Access Compliance Report Public Rights-of-Way (Pedestrian Signals)

Main Street: YORBA_LINDA_BLVD Cross Street: KELLOGG_DR Location: SW

ADA ID: SGAT210922144940 Signal Type: One Push Button-Non APS Overall Compliance: No Severity Scores: BTN 1: 35 BTN 2: N/A No BTN: N/A

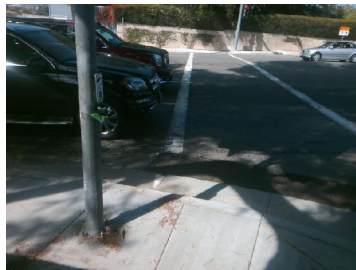
OC Std/PROW: R404.2, MUTCD 4e.08

Possible Solutions: Replace Signal Push Button With APS Button. Remove and Replace Clear Space.
